Clondalkin

Draft Local Planning Framework

Chief Executive's Report for Proposed
Variation 1 to the County Development
Plan

November 2025

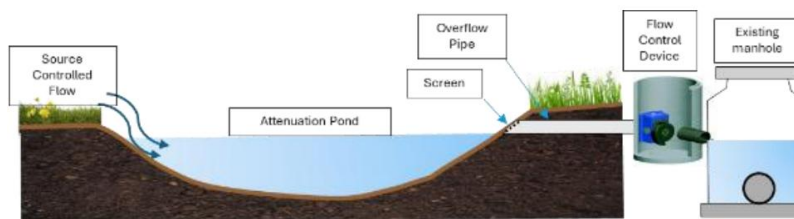
Having regard to flood risk management, and in particular, the Planning System and Flood Risk Management Guidelines for Planning Authorities (2009) and the recently published LAWPRO’s planning guidance on Implementation of Urban Nature-based Solutions, Guidance Document for Planners, Developers and Developer Agents (2025), the Planning Authority is advised to:

- Review opportunity sites with the Local Planning Framework area in the context of SuDS, where integrated and area-based provision of SuDS and green infrastructure can be incorporated in order to avoid reliance on individual site by site solutions; and
- Include the present-day flood risk mapping for Clondalkin as a distinct layer within the Strategic Flood Risk Assessment to demonstrate the current predicted flood risk.

Add 'Stormwater Management' section in A1.1:

'The site is predominantly greenfield and relatively large, providing excellent scope to implement an integrated and sustainable stormwater management strategy. Given its size, the area lends itself well to a masterplan-based SuDS design, where runoff from different development parcels can be managed collectively rather than through separate, site-by-site systems. A stormwater attenuation basin could be strategically located along the southern boundary near River Camac if the topography allows. This basin would serve as the main control feature, temporarily storing surface water before releasing it at a restricted rate—kept to the greenfield runoff equivalent or a practical minimum of 2 L/s in accordance with CIRIA guidance. A typical schematic for such site is illustrated below: Additionally, source control SuDS measures such as swales, rain gardens, and permeable paving should be incorporated within individual plots to slow, treat, and retain runoff close to where it falls. These measures will contribute to the overall network, reducing reliance on hard-engineered solutions and enhancing biodiversity and amenity. Exact location of attenuation site will depend on topographical and hydraulic assessment during later design stages.'

And add the following image in the 'Stormwater Management' section in A1.1:

Extract from Figure 5.9 of the LPF outlining the proposed permeability link from the Ninth Lock Road as far as Woodford Road.

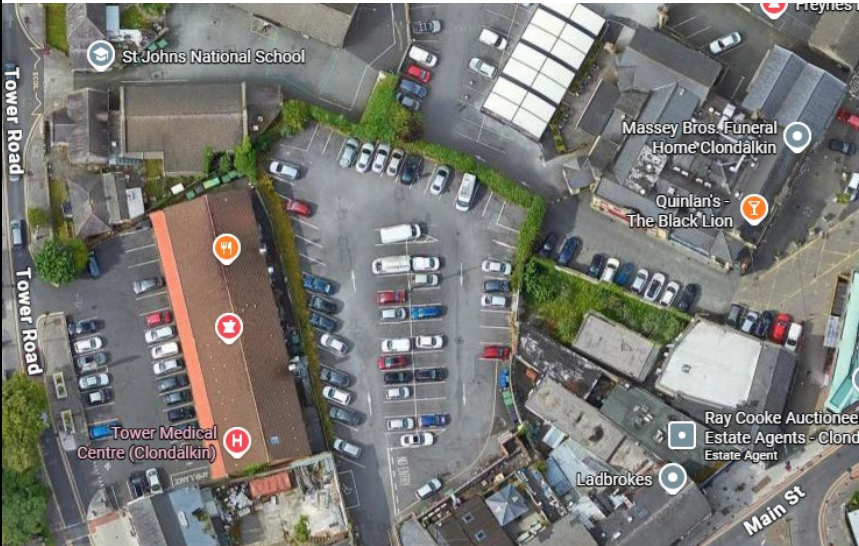
SD-C367-21 Janis Quane	Though submissions recognised that permeability does provide many benefits, it is not something which should be forced on long-established communities, particularly those with ongoing anti-social behaviour. A number of submissions stated there is an IPAS accommodation unit located along Monastery Road, and have raised concerns with those using this accommodation transitioning through the estate to get elsewhere.	 Image extracted from Figure 5.9 of the LPF, highlighting the potential connection between Monastery Heath and Woodford Estate, which would create shorter routes to schools, with the barrier to this connection shown as a circle. The ‘<i>Permeability Best Practice Guide</i>’ (NTA, 2012) is included as an objective in the LPF, and is therefore aligning with H7 Objective 3 in the County Development Plan which states: H7 Objective 3: <i>To support the principle of permeability schemes that provide improved connections between housing estates and their surrounds for walking and cycling, having regard to the National Transport Authority’s Permeability Best Practice Guide (2015) or any subsequent guidelines, including the provisions relating to permeability schemes and anti-social behaviour.</i>

The potential for this route is recognised as a long-term aspiration. It would provide for improved east-west connections within the LPF. Should mixed use or residential development come forward within the current industrial estate, which is provided for within the current town centre zoning, the identification of this route will ensure that opportunities to incorporate it into proposed development are not

lost. The link would also facilitate greater integration with development on the Ninth Lock Framework site, noting that it is an objective to have community facilities within the site along the Ninth Lock Road. The route would also facilitate access to the new BusConnects upgrades along New Nangor Road for those within Riversdale and Mayfield. The '<i>Permeability Best Practice Guide</i>' (NTA, 2012) is included as an objective in the LPF, and is therefore aligning with H7 Objective 3 in the County Development Plan which states: <i>H7 Objective 3: To support the principle of permeability schemes that provide improved connections between housing estates and their surrounds for walking and cycling, having regard to the National Transport Authority's Permeability Best Practice Guide (2015) or any subsequent guidelines, including the provisions relating to permeability schemes and anti-social behaviour.</i> It is recognised that the potential for anti-social behaviour, including safety and security, is a significant concern to the community. The NTA Guide provides examples and detail around best practice in the implementation of opening barriers to movement, the need for universal access and reducing the potential for anti-social behaviour would be included in design considerations. It is an objective within the LPF to:

SM4 Objective 2: <i>To ensure that proposed permeability links are designed in line with the NTA's best practice guidance and in such a way as to reduce the potential for anti-social behaviour, providing wide and inviting openings which are well lit.</i> In addition, a number of objectives in the LTP also make clear that local consultation with communities within which the permeability measures are proposed will be undertaken <u>before</u> implementing any proposed measures. <u>SM4 Objective 1</u> looks to '<i>support the permeability routes and links identified in Figure 5.9 and Table 5.4, <u>subject to further consultation</u>, which will enable quicker and safer access to schools, shops, places of work and social interaction in a pedestrian and cycle friendly environment</i>' There are also multiple objectives relating to the different categories of permeability routes in the LPF to ensure consultation prior to delivery: <i>SM5 Objective 1: To deliver the identified priority permeability routes, subject to local consultation, to facilitate improved connections to schools, increasing the safety of children currently using active travel and providing improved options for</i>

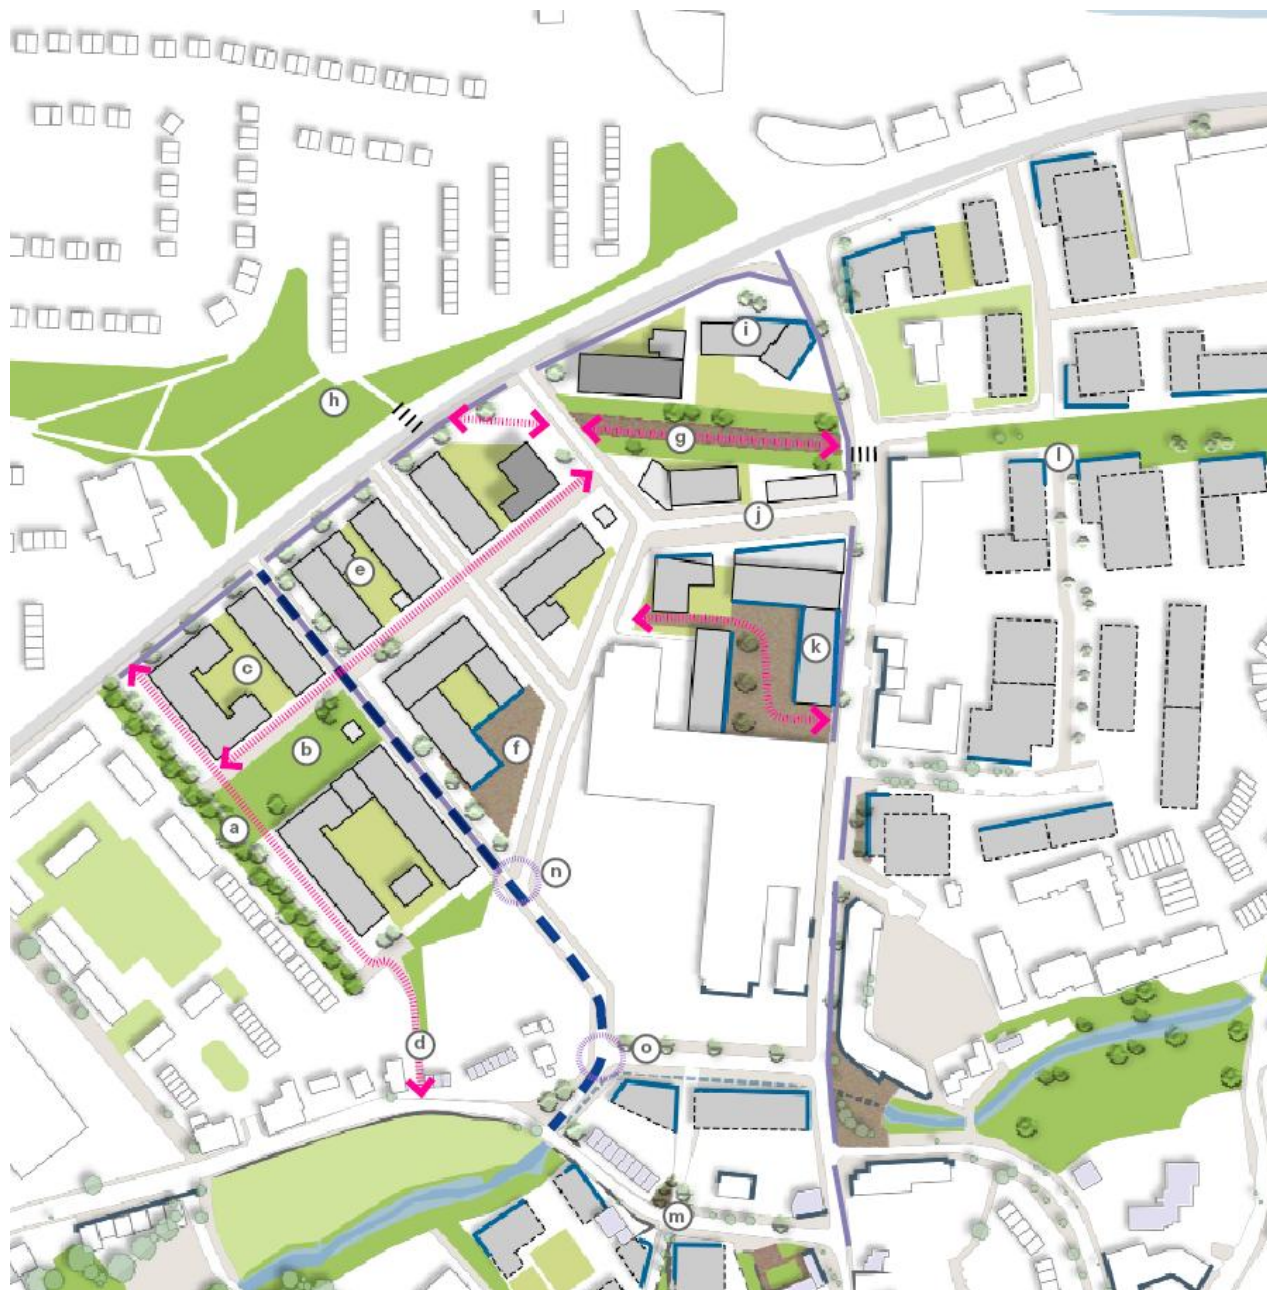
Village Centre Framework Site		
Submission No.	Submission Summary	CE response and recommendation
SD-C367-159 Monica McGill	Village Centre Framework Site The submission queries whether the council will correct Figure 8.10 on Page 91 and the fosse line as it is not limited to the concrete buttress. The submission notes that on Page 75 it states, "The distinctive curve of Orchard Road follows the boundary of the former monastic enclosure (fosse)."	CE Response: The fosse where it is wholly legible either on site or on review of maps is outlined on Figure 8.10 in a yellow colour.

Plinth on Orchard Rd. indicative of line of fosse. The fosse has been identified to the extent possible without detailed archaeological examination. This type of archaeological work is not possible at this time. Having regard to this, the map shown in Figure 8.10 and the description of the fosse, alongside this area being within an archaeological zone of notification is considered sufficient to support the assessment of any planning applications. CE Recommendation: No change to Draft LPF.
--	--	--

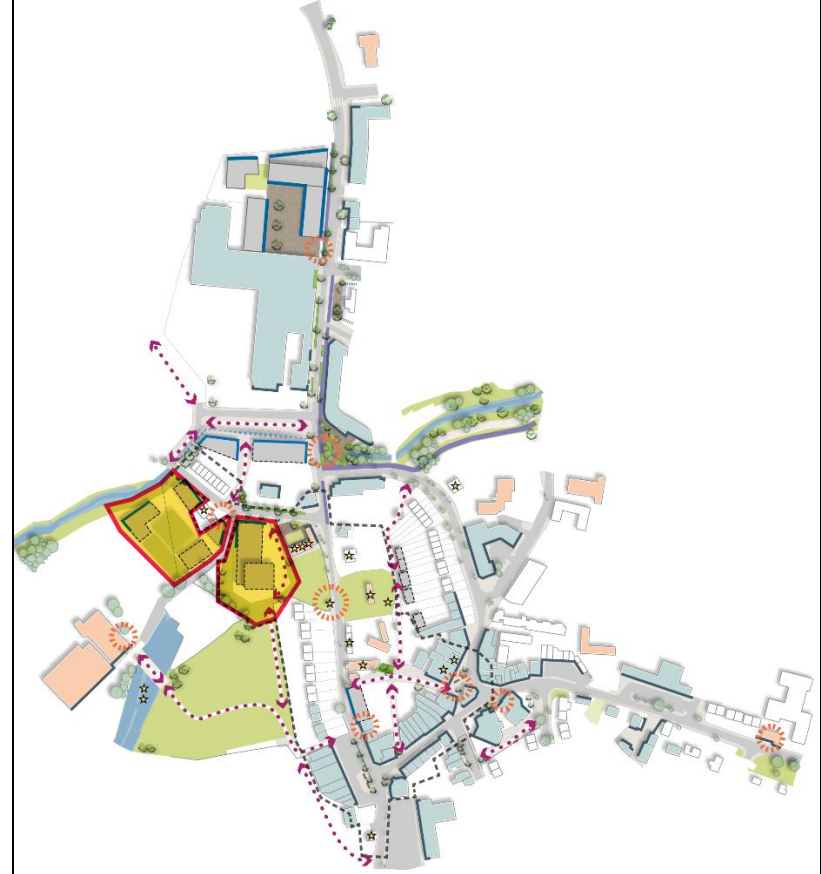
redesign and creating short and long term disruption to the busy retail centre. Though the Mini framework plan proposes development opportunities with proposed units aligning to the path of the Camac, the location of them overshadows the proposed active route outlined in the LPF, the existing car park and the Mill Shopping Centre. This is turn will reduce the Mill's visibility and street presence on Tower Road and Old Nangor Road.	to placemaking within Clondalkin and to the environment around the shopping centre, it is recognised that there may be feasibility and other issues which make it difficult to achieve. The Council would be willing to work with the landowner to investigate whether there are any funding mechanisms which could help bring this forward. The submission is concerned at the estimated loss of car parking spaces that development may necessitate. Should development come forward, consideration would have to be given to the rationalisation of car parking, ensuring that it continues to meet the needs of those using the shopping centre. The mini-framework is not requiring development on the site but it is recognising that there may be potential on the site for development and in that regard, it is setting out design parameters to guide development in the event that a planning application comes forward. It is also noted that SM5 Objective 3 needs to be changed for clarity purposes: <i>To ensure that new development and key lands maximise the potential for active travel connectivity between the site to the village centre, local services and schools and to public transport'</i> CE Recommendation: Amend SM5 Objective 3:

From <i>‘To ensure that new development and key lands maximise the potential for active travel connectivity between the site to the village centre, local services and schools and to public transport’</i> To <i>‘To ensure that new development and key lands maximise the potential for active travel connectivity between areas outside the village centre, including the Ninth Lock Framework site, to the village centre, local services and schools and to public transport.’</i> And Amend Figure 8.32 on page 104 to remove reference to ‘vehicle movement’ and to illustrate more clearly the long term high capacity public transport route, as identified in the adopted County Development Plan. And Include the identification of the permeability links in the Figure 8.32 Key, identified as ‘n’ and ‘o’ between the Ninth Lock Framework site and the Mill Centre site, as shown on the revised map below.
--	--	--

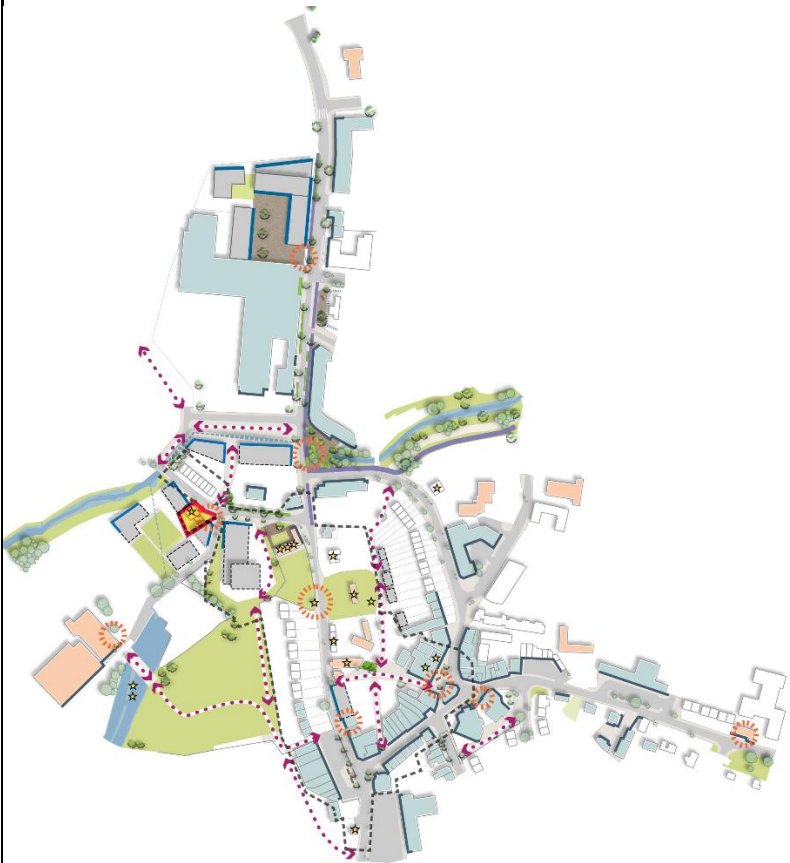
SD-C367-55 Cllr Francis Timmons	Old Nangor Road Infill Site The submission refers to Figure 8.15 on page 83 of the Local Planning Framework and requests that the image makes clear whether the Old Nangor Road is one or two way.	CE Response: The submission is noted. For clarity, it is noted that Figure 8.15 is on page 93. The image on Old Nangor Road is intended to convey that it remains two way. However, it is acknowledged that the graphics could be improved to make this more clear. It is also noted that the site location of the Old Nangor Road Mini Framework in Figure 8.13 is incorrect and needs to be corrected. CE Recommendation: Amend Figure 8.13 on page 93 to illustrate the correct location of the Old Nangor Road Mini Framework location.
--	---	---

And amend Figure 8.15 on page 93 to illustrate more clearly that Old Nangor Road is two way.
